ALARM EF0 (EF3) IN APPLIANCES HEC ARCHED

EN	Publication no.	599 71 70-63	Rev. 00	03/2009	dmm
----	-----------------	---------------------	---------	---------	-----

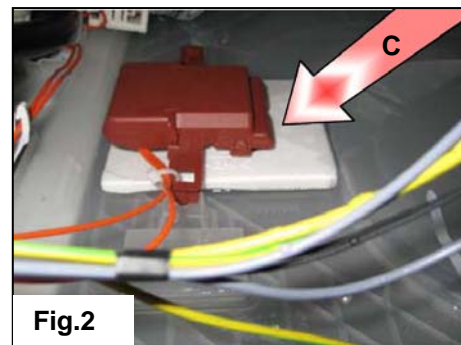
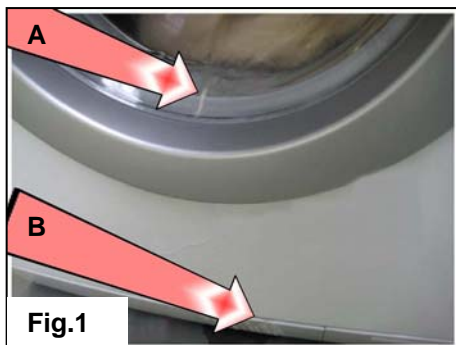
In some cases it may happen that some small pieces of clothes infiltrate between the door and the rubber bellow (fig.1 A). This causes a small water leakage, which through the front panel/plinth junction (fig.1 B), flows inside the appliance, thus switching on the Aqua Control sensor (fig.2 C) and generating alarm EF0/EF3.

Incline the washing machine of about 10 cm to spill the water, so that the sensor can operate normally again.

Remove the plinth and stick the self-adhesive seal, part no. 125 11 39-10/9, to the wall which is in contact with the front panel, as represented in figure.

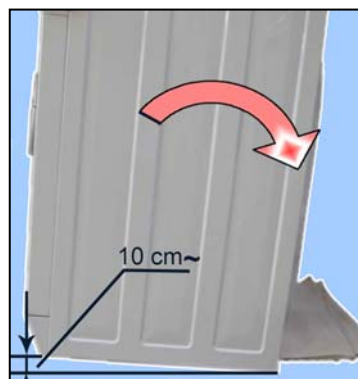
To avoid the switching on of the sensor due to this problem:
